**IEEE Std 802.3cb™-2018**  
(Amendment to IEEE Std 802.3™-2018)

## **Amendment 1: Physical Layer Specifications and Management Parameters for 2.5 Gb/s and 5 Gb/s Operation over Backplane**

**Abstract:** Ethernet Media Access Control (MAC) parameters, Physical Layer specifications, and management objects for the serial transfer of Ethernet format frames at 2.5 Gb/s and 5 Gb/s over electrical backplanes are defined in this amendment to IEEE Std 802.3-2018.

**Figure 69–4—Architectural positioning of 2.5 Gb/s and 5 Gb/s Backplane Ethernet**

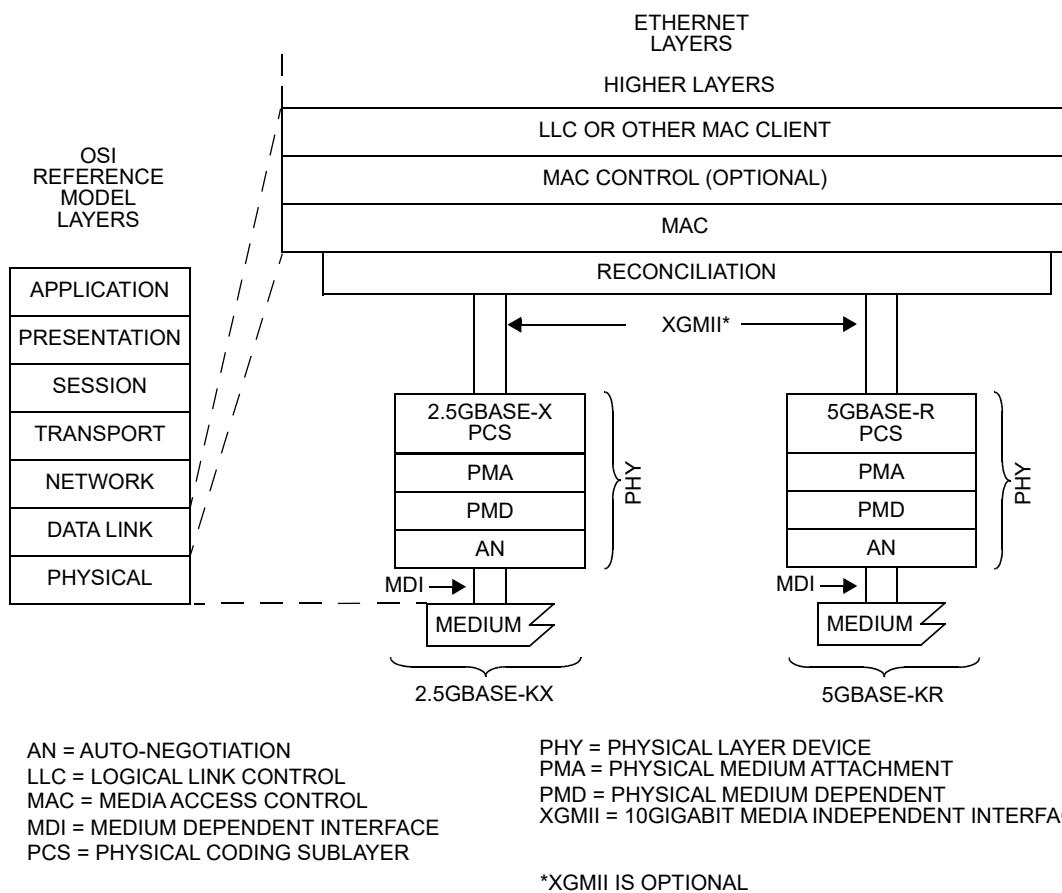
*Insert the new figure on the next page (Figure 69-4) after Figure 69-3.*

**Figure 73–1—Location of Auto-Negotiation function within the ISO/IEC OSI reference model**

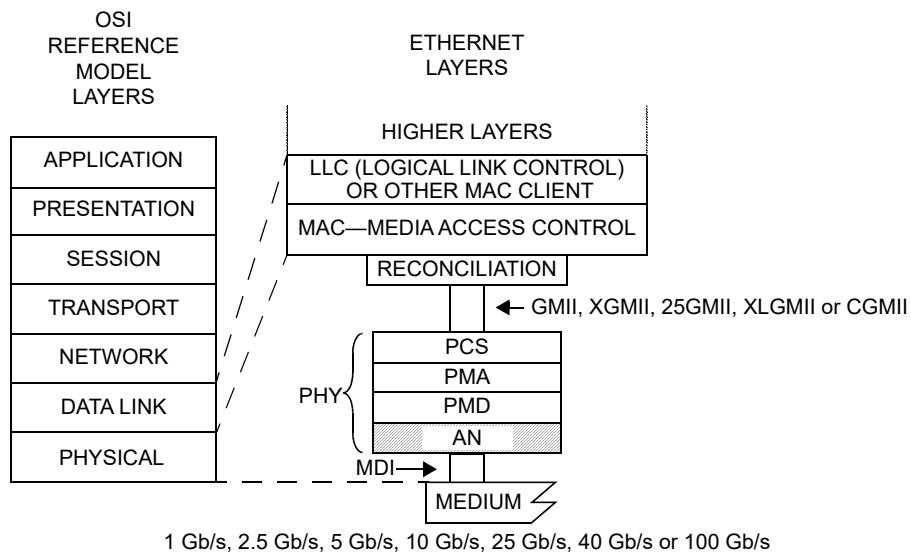
*Replace Figure 73–1 with the following figure (which adds 2.5 Gb/s and 5 Gb/s in the medium rates):*

**Figure 125-1—Architectural positioning of 2.5 Gigabit and 5 Gigabit Ethernet**

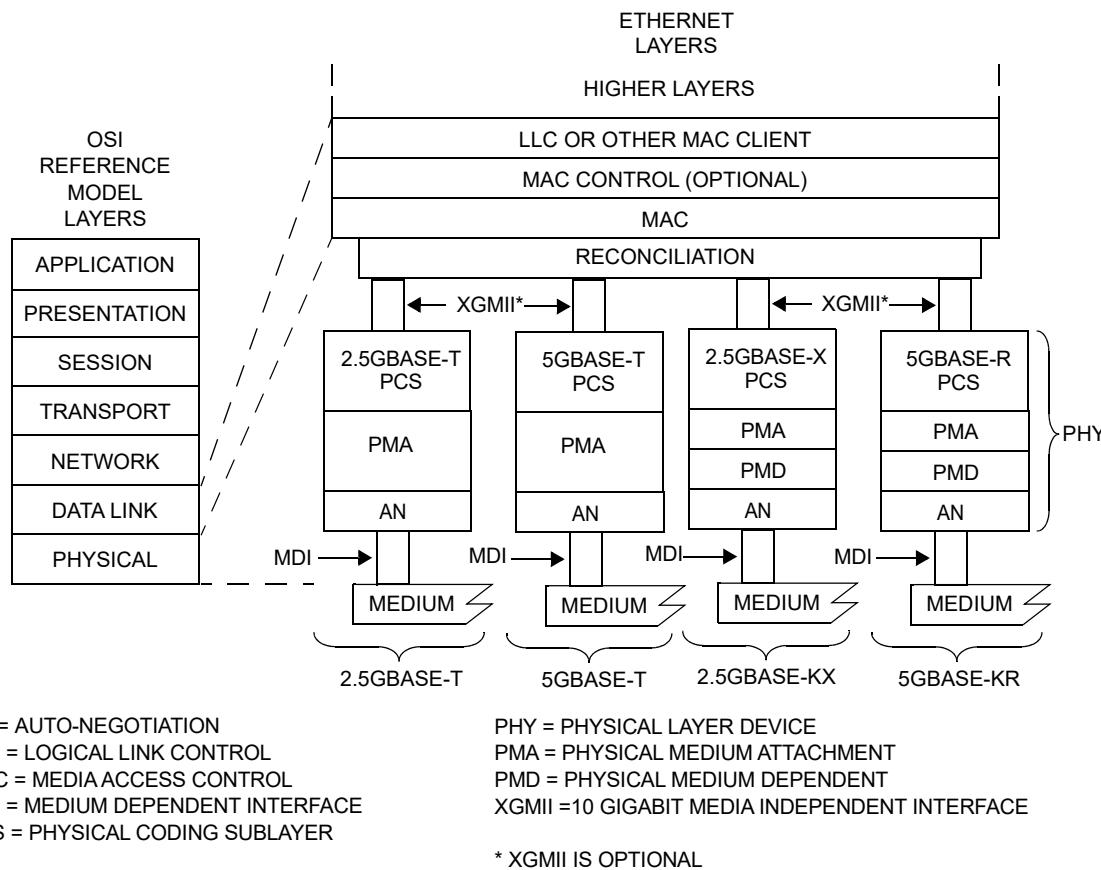
**Replace Figure 125-1 with the following figure (which adds the 2.5GBASE-KX and 5GBASE-KR related layer diagram):**

**Figure 69B–2—Fitted attenuation limit for 1000BASE-KX, 10GBASE-KX4, 10GBASE-KR, and 40GBASE-KR4**

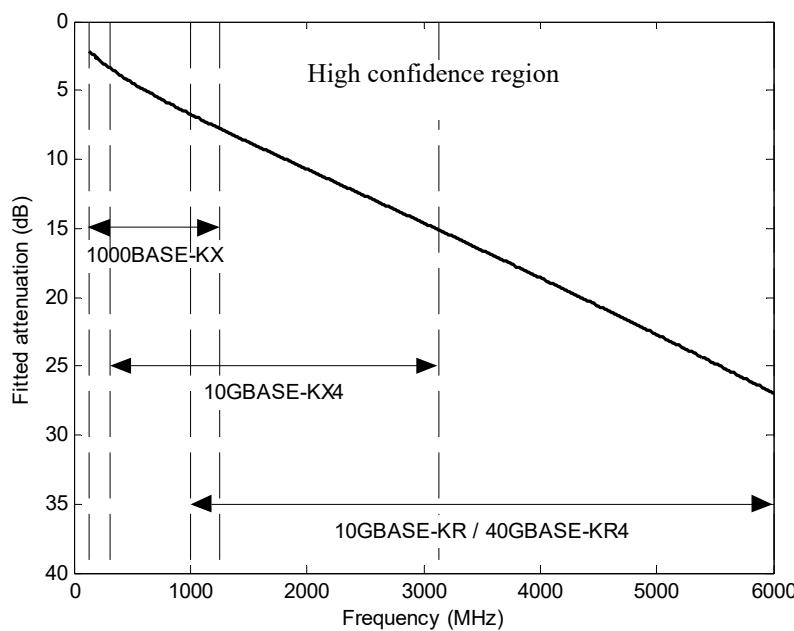
*Change the title of Figure 69B–2 as shown (the figure art remains unchanged):*

**Figure 69B–2a—Fitted attenuation limit for 2.5GBASE-KX and 5GBASE-KR**

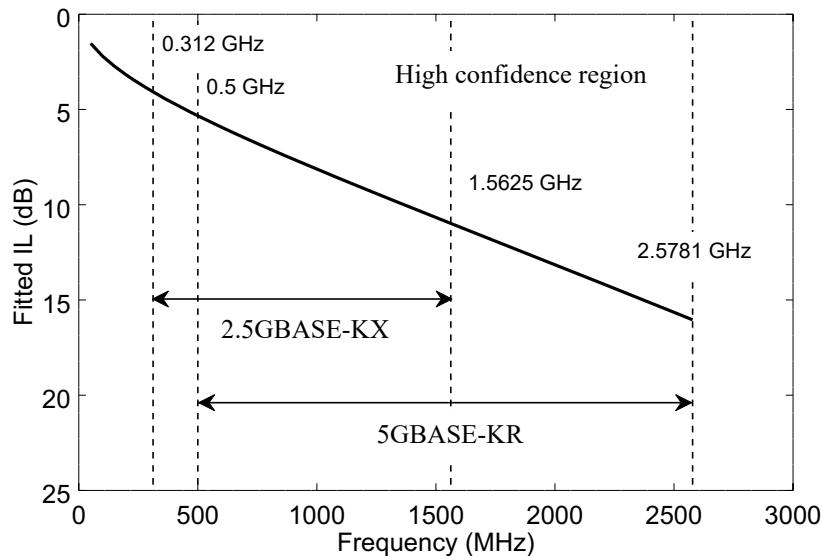
*Insert the following new figure (Figure 69B–2a) after Figure 69B–2:*

Figure 69B-5a—Insertion loss limit for 2.5GBASE-KX

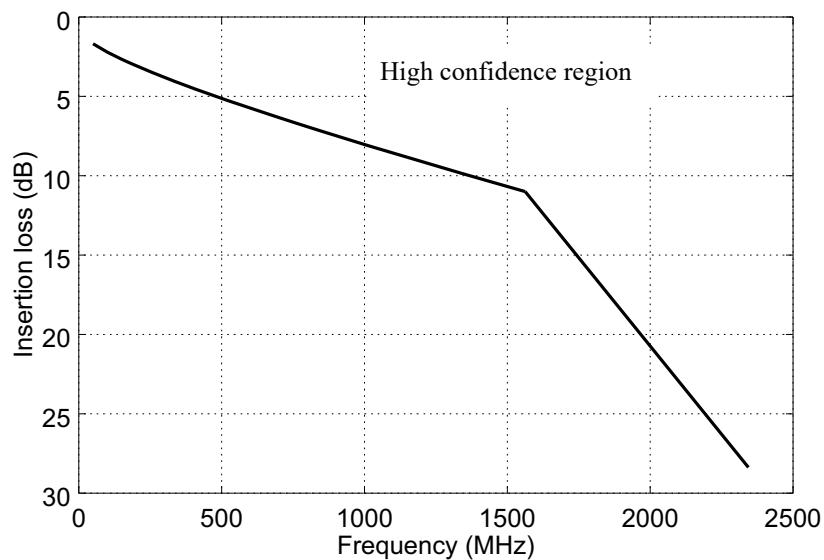
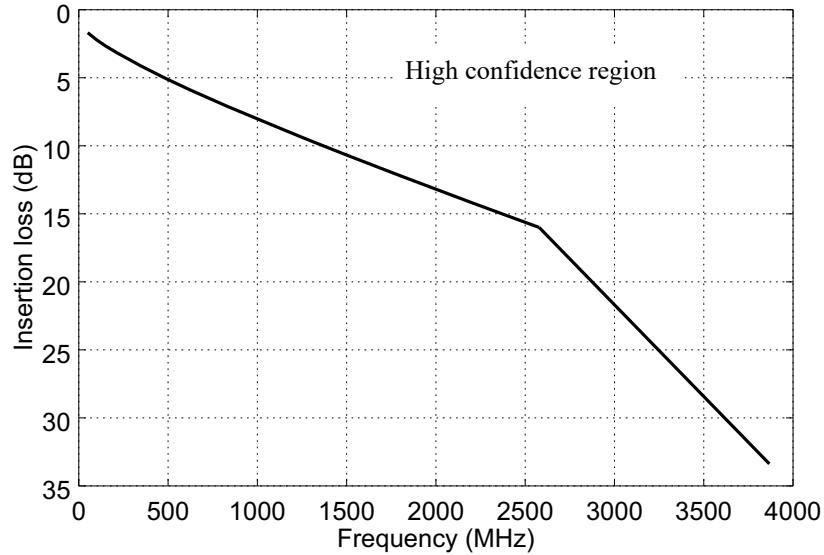
Insert the following new figures (Figure 69B-5a and Figure 69B-5b) after Figure 69B-5:

**Figure 69B–6—Insertion loss deviation limits for 1000BASE-KX,  
10GBASE-KX4, 10GBASE-KR, and 40GBASE-KR4**

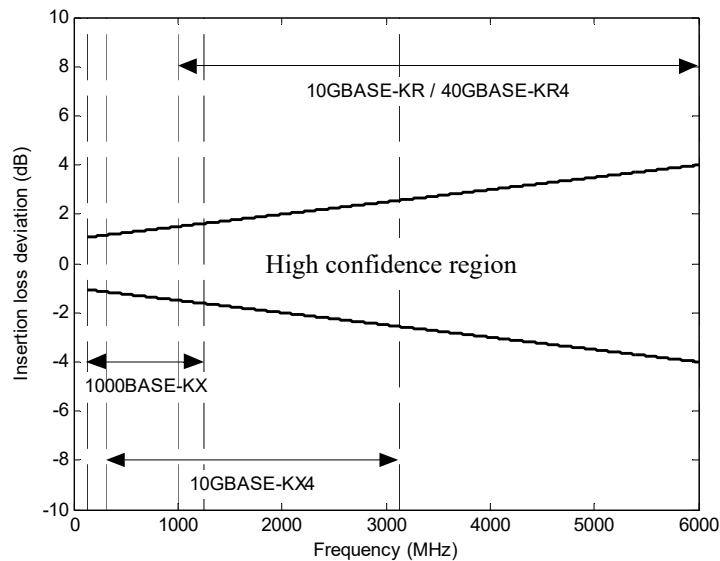
*Change the title of Figure 69B–6 as shown (the figure art remains unchanged):*

**Figure 69B–6a—Insertion loss deviation limits for 2.5GBASE-KX and 5GBASE-KR**

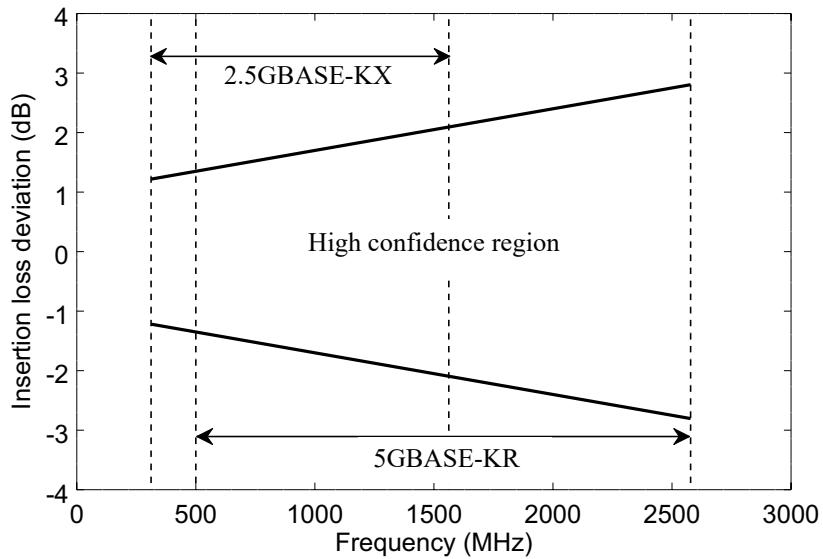
*Insert the following new figure (Figure 69B–6a) after Figure 69B–6:*

**Figure 69B-7—Return loss limit for 1000BASE-KX, 10GBASE-KX4, 10GBASE-KR, and 40GBASE-KR4**

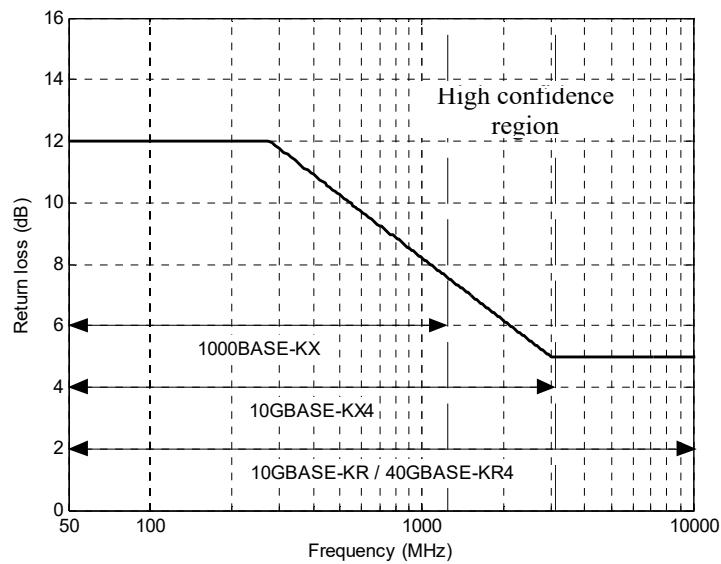
*Change the title of Figure 69B-7 as shown (the figure art remains unchanged):*

**Figure 69B-7a—Return loss limit for 2.5GBASE-KX and 5GBASE-KR**

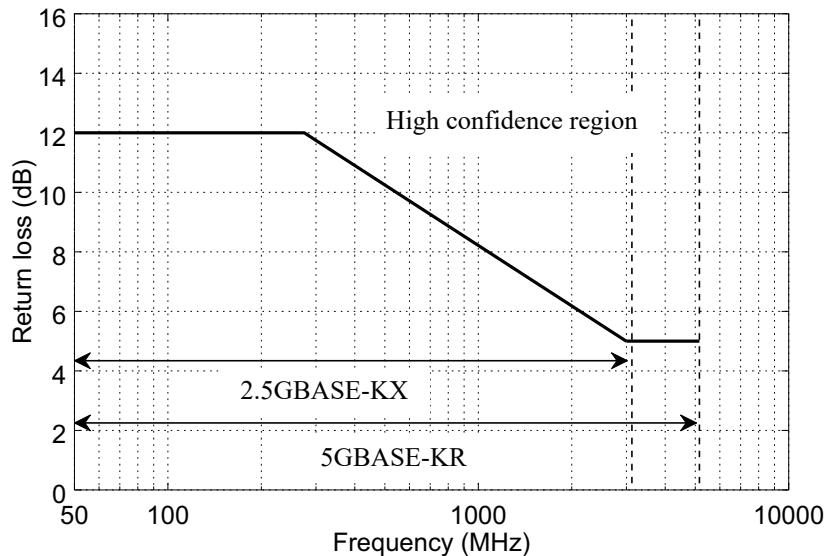
*Insert the following new figure (Figure 69B-7a) after Figure 69B-7:*

**Figure 69B-8—Insertion loss to crosstalk ratio limit for 1000BASE-KX, 10GBASE-KX4, 10GBASE-KR, and 40GBASE-KR4**

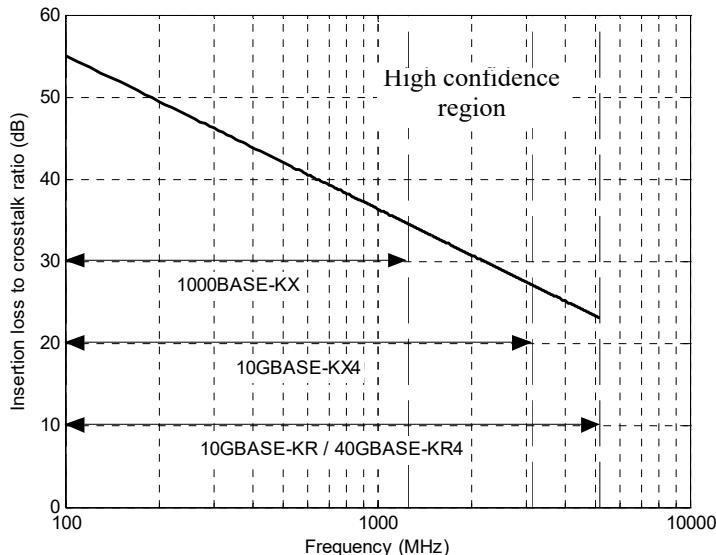
*Change the title of Figure 69B-8 as shown (the figure art remains unchanged):*

**Figure 69B-9—Insertion loss to crosstalk ratio limit for 2.5GBASE-KX and 5GBASE-KR**

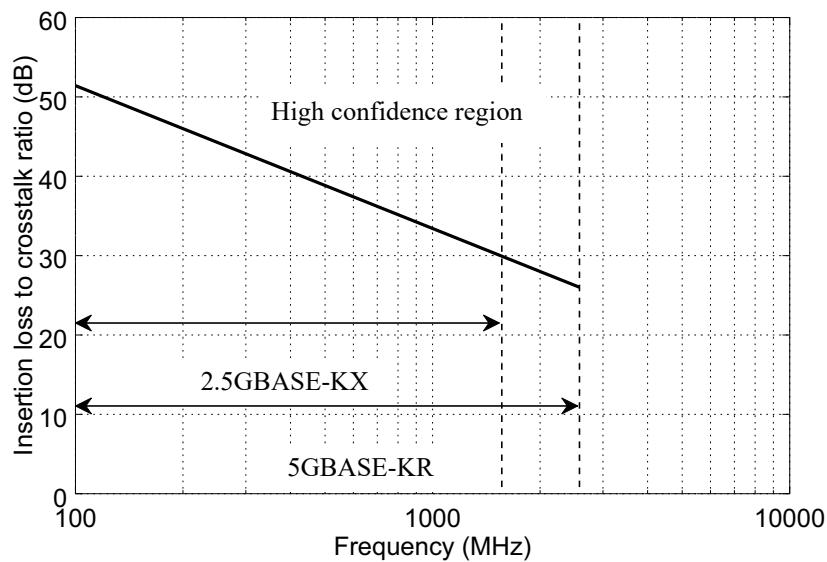
Insert the following new figure (Figure 69B-9) after Figure 69B-8:
